RE: Further Evaluation of Langan Slope Stability Analysis, January 14, 2025, revised June 18, 2025
PB-24-01 West Essex Highlands, Inc
Block: 179 Lot: 32 Zone: IH-1
Warner Road
Project 2151.001

Figure 3: Cross Section C with Bedrock Layer of GSI=20

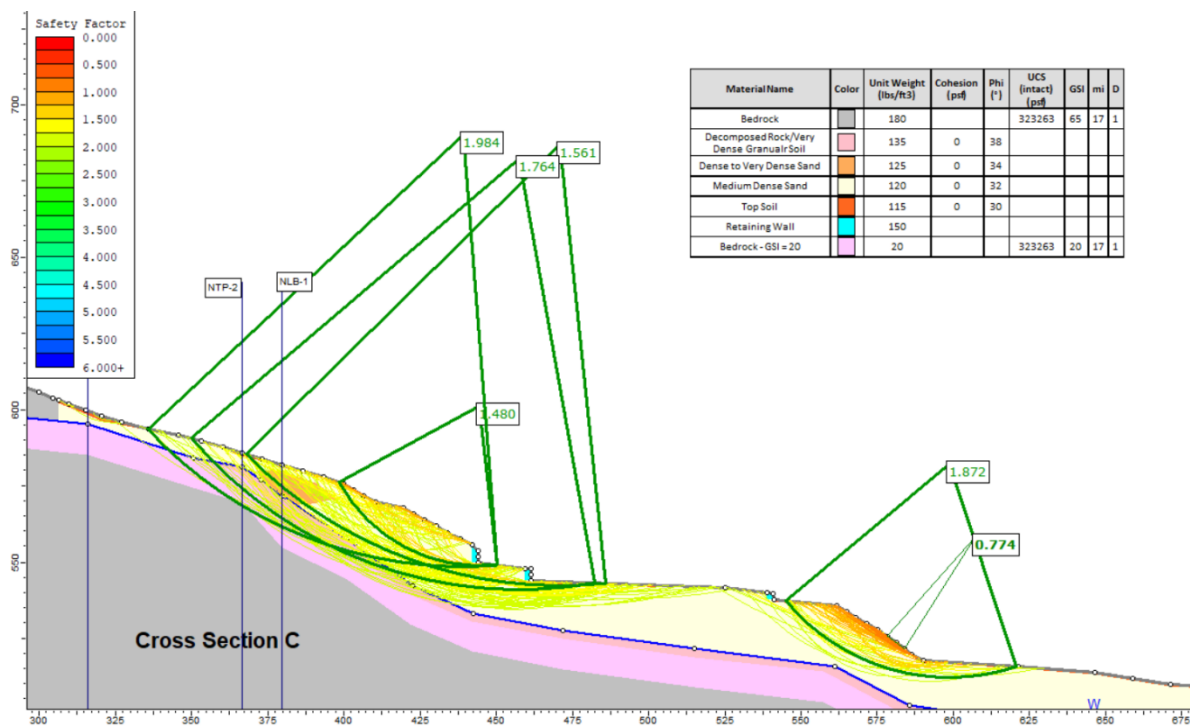
As I previously testified, a weak rock mass, particularly in the northeastern area of the site, was indicated by the low Rock Quality Designation (RQD) values. A Geological Strength Index (GSI) value reflective of the poor and very poor joint conditions, common in heavily fractured rock, should be considered. A ten-foot-thick layer of bedrock with weaker parameters was added to the models below the decomposed bedrock layer to represent the 10 feet of rock coring performed during the soil borings. Model trials of Cross Sections C and D were evaluated with a GSI value of 20. The other rock material properties selected by Langan were maintained to inform this sensitivity analysis. Figures 3 and 4 below provide a zoomed view of the potential failure surfaces with factors of safety below 2.0 for both cross sections.

Numerous slip surfaces extending deeper into the subsurface were uncovered for both cross sections.
